Model: Sh-MF1	Date: 10-Aug-11	No.: RM052001c
---------------	-----------------	----------------

Subject: Firmware Release Note: Fax		Prepared by: T. Tachibana	
From: 1st Tech Service Sect., MFP/Printer Tech Service Dept.			
Classification:	<input type="checkbox"/> Troubleshooting <input type="checkbox"/> Mechanical <input type="checkbox"/> Paper path <input type="checkbox"/> Product Safety	<input type="checkbox"/> Part information <input type="checkbox"/> Electrical <input type="checkbox"/> Transmit/receive <input checked="" type="checkbox"/> Other (Firmware)	<input type="checkbox"/> Action required <input type="checkbox"/> Service manual revision <input type="checkbox"/> Retrofit information <input checked="" type="checkbox"/> Tier 2

Model: Sh-MF1		Date: 09-Nov-11	No.: RM052023
Subject: CPU and firmware Change Notification		Prepared by: T.Hirai	
From: 3rd Tech Service Sect., MFP/P Tech Service Dept.			
Classification:	<input type="checkbox"/> Troubleshooting <input type="checkbox"/> Mechanical <input type="checkbox"/> Paper path <input type="checkbox"/> Product Safety	<input checked="" type="checkbox"/> Part information <input type="checkbox"/> Electrical <input type="checkbox"/

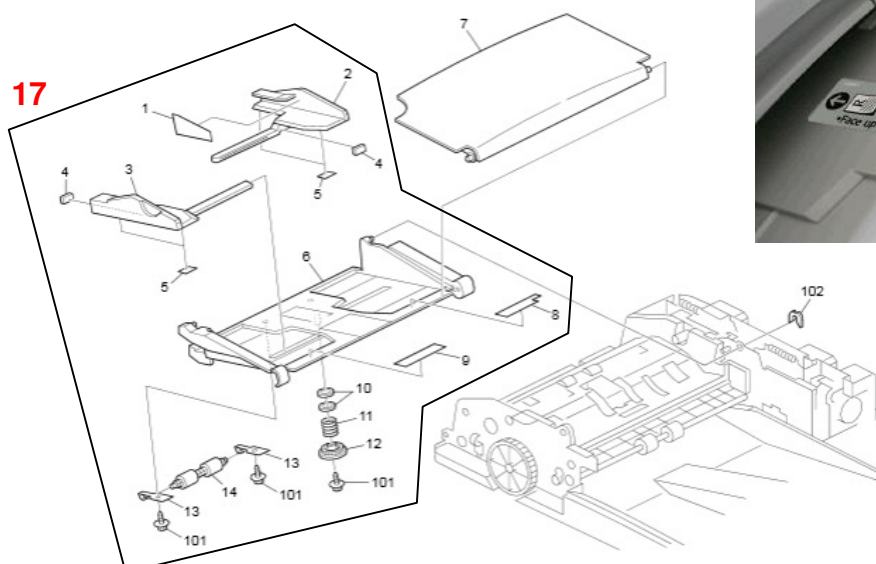
- The "Clip" and "Staple" illustrations were moved from the side fence decal (Decal: Side Fence) to the original table decal (Decal: Original Table).
- The illustration showing the capacity of the original table was further emphasized on the side fence decal.

**Reason:** To prevent original jams caused by too many originals loaded on the original table.
